SUBJECT: Calvert Cliffs Nuclear Power Plant
Unit No. 1; Docket No. 50-317
Response to NRC Request for Additional Information Regarding our letter dated
May 31, 2006, "ASME Code Section XI Flaw Evaluation of Dissimilar Metal
Weld Flaws Identified by Ultrasonic Testing"

**CALVERT CLIFFS NUCLEAR POWER PLANT RESPONSE TO THE
NRC REQUEST FOR ADDITIONAL INFORMATION**

ULTRASONIC EXAMINATION EVALUATION SHEETS

Weld Number 4" CC10-1006 (W-1)

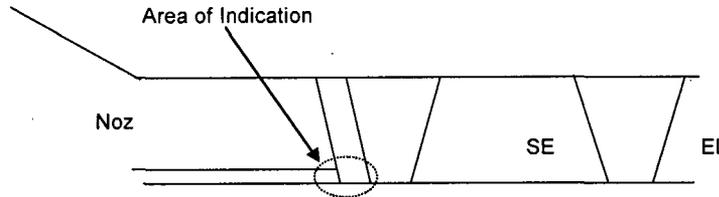
Provide sketches or diagrams to show the locations of the indications in the surge and drain line nozzles. The sketches should include the nozzle, safe end, weld, and pipe. The sketches should show whether the indications are surface connected or embedded.

Type of Flaw : Suspect PWSCC

Axial Indication detected on Nozzle Side at approx. 1.0" CW
